KINGSTON FOSSIL PLANT (KIF) - ANNUAL ASH POND DIKE STABILITY INSPECTION

ANNUAL ASH POND DIKE
STABILITY INSPECTION

Prepared by: John Albright
Date: November 9, 2001

Photo 1 - Dike C and Lower Dike Road

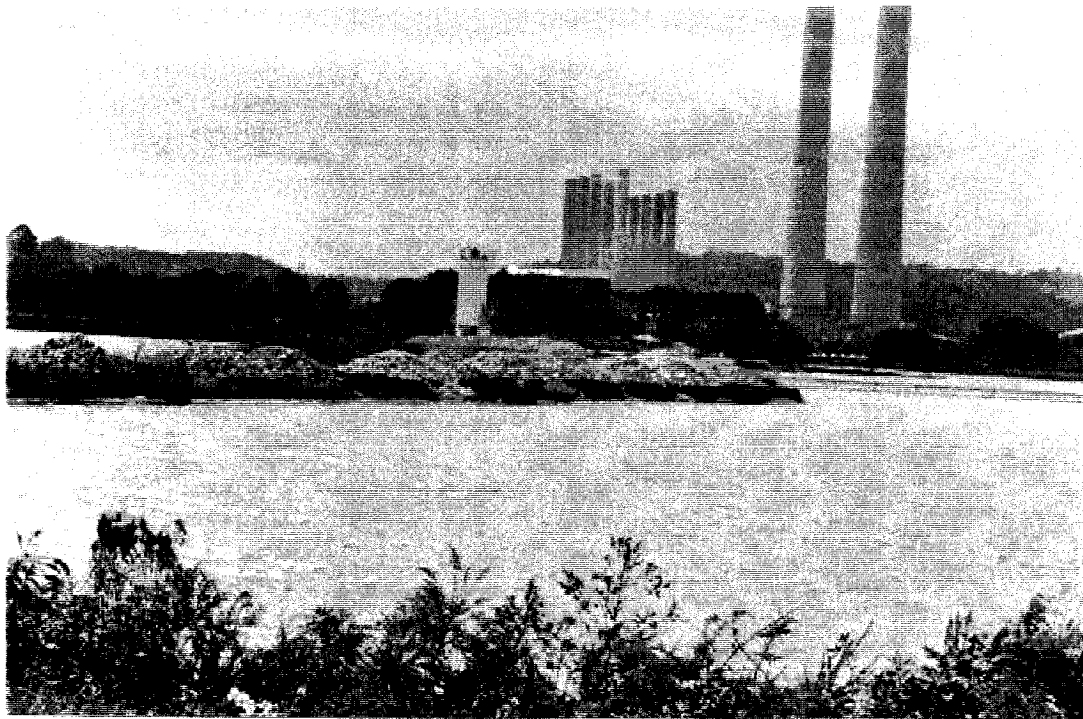
All dike roads were in good condition with a good ash or crushed stone surface except for the lower dike road along the east side of the pond (Dike C). The lower road has grown up with vegetation (see photo 1). There were two areas of the lower dike road that were rutted and held water making vehicle passage difficult.

- Repair the ruts in the lower dike along the stilling pool and Dike C by filling with soil, compacting it, grading the road to turn water to the outside, and covering the repairs with ¾" crushed stone. It is estimated the length of both repairs is 30 feet, requiring about 3 yards of soil to fill the ruts and 12 tons of stone for cover.

Photo 7 - Current Condition Of Cell 2/3

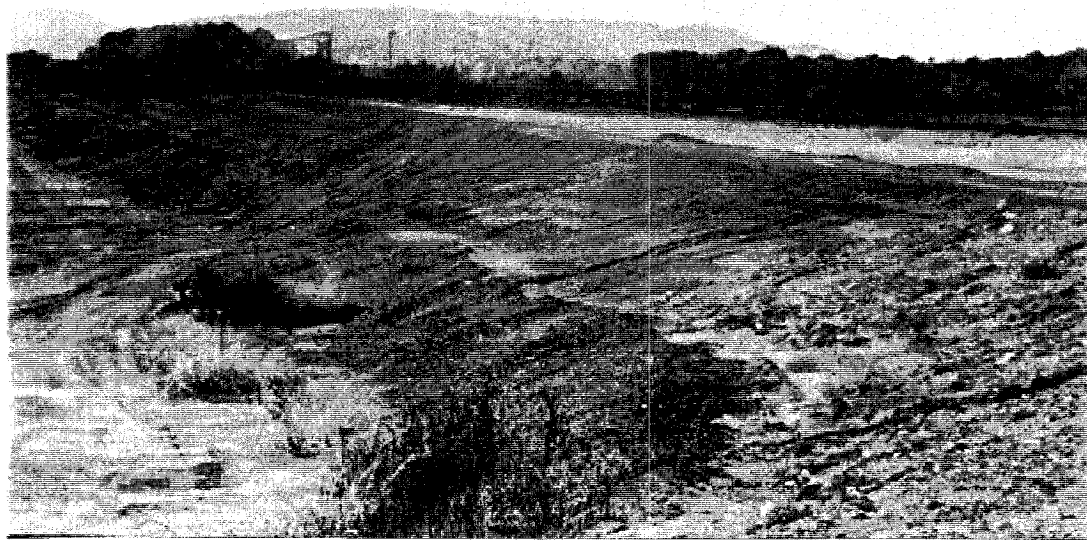
Dredge cells No. 2 and 3 were combined last year. The top of dike elevation for Cell 2/3 is now elevation 805. The dike for Cell No. 1 is also at elevation 805. Cell 1 was being dredged into at the time of inspection. Cell 2/3 was dry, but a combination of sparse vegetation and a crust on the ash was preventing dusting.

Figure 1 – Original Materials

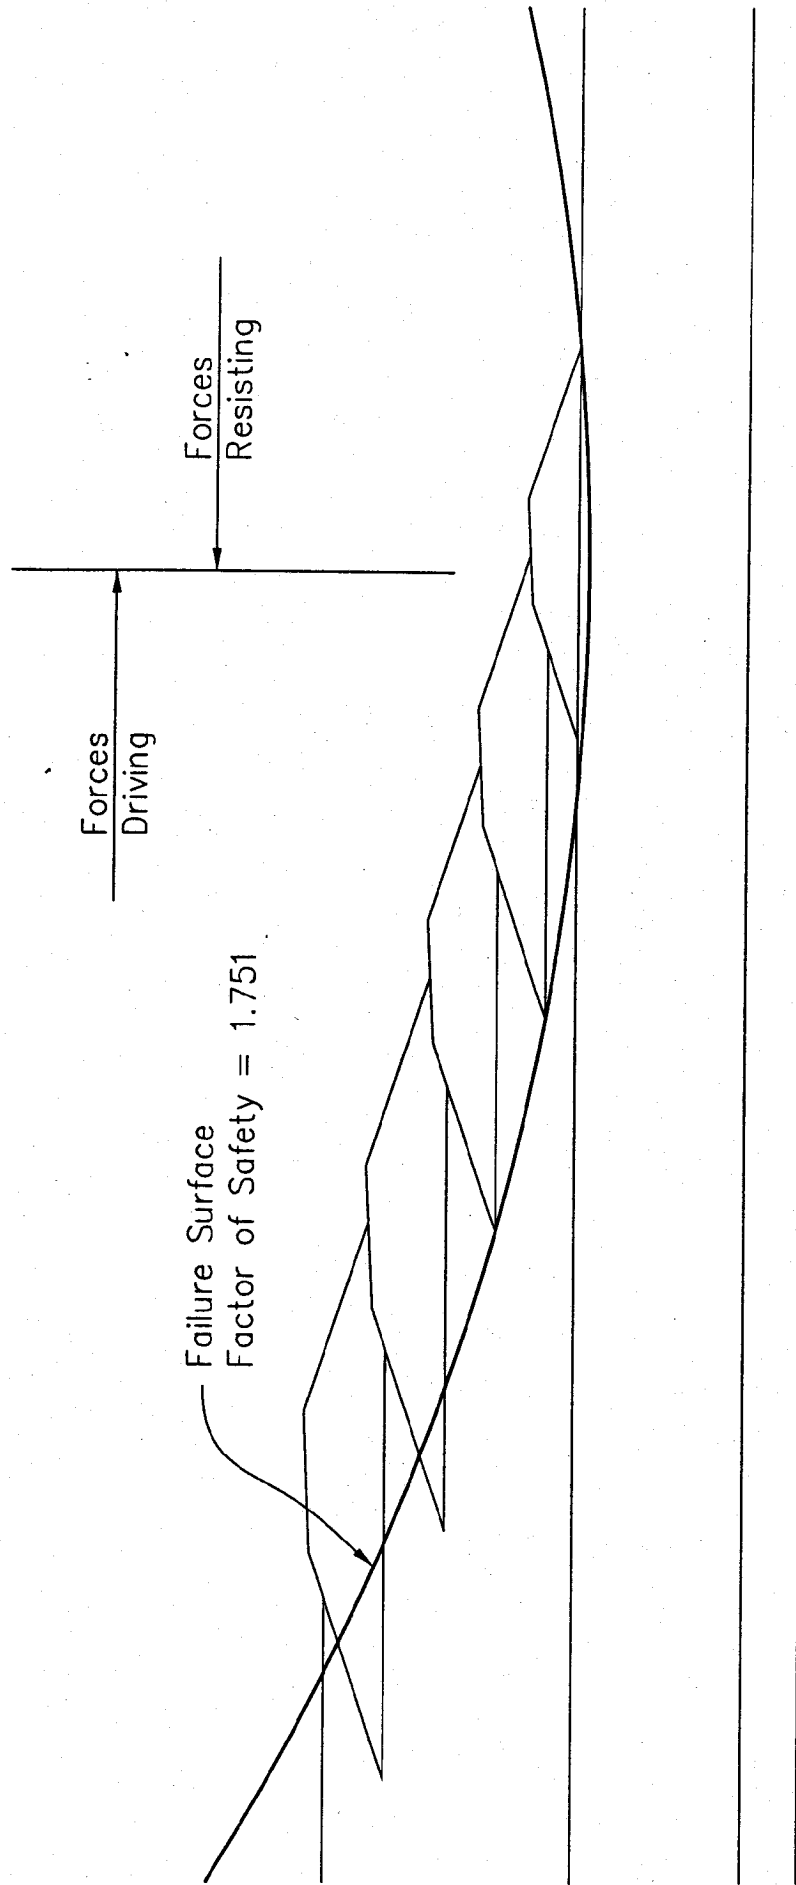
The factor of safety for long term stability using these parameters is 1.75. The earthquake factor of safety is 1.17. These were presented to the state in the permit. Figure 1 shows the failure plan for this condition as analyzed using UTexas3.

Figure 2 - Revised Materials

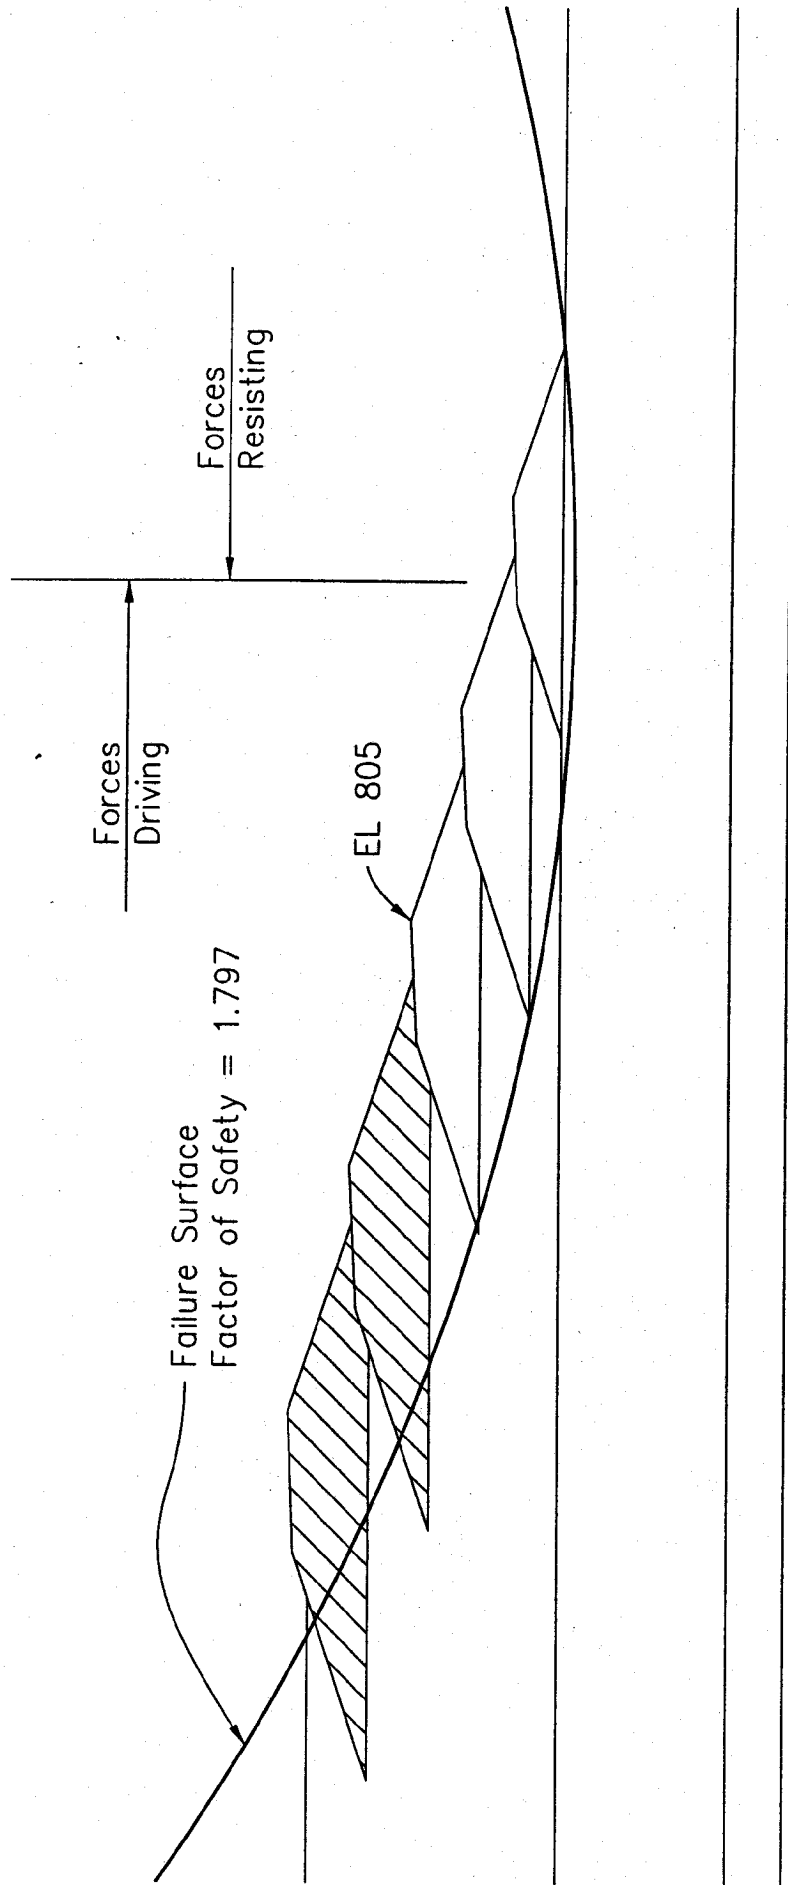
long term stability using these parameters is 1.80. The earthquake factor of safety remains the same at 1.17. Figure 2 shows the failure plan for this condition as analyzed using UTexas3.

Studying the difference between Figures 1 and 2 shows how the factor of safety went up slightly after substituting the apparently weaker material in the dikes. The weakest failure plane remains thru the base of the stack. The reduction in the cohesion values (mixed ash to fly ash) does not play a significant role in the stack's long term Factor of Safety. The lighter weight of the material applied at the upper driving wedge of the failure circle has the most influence in the static force computations to increase factor of safety. Had pure fly ash been used at the lower levels of the dredge cell construction there could have been a dramatic reduction in the factor of safety.

Consequently, we concur that it is acceptable to construct the remaining lifts of the dredge cell using fly ash compacted to at least 95% Standard Proctor density.
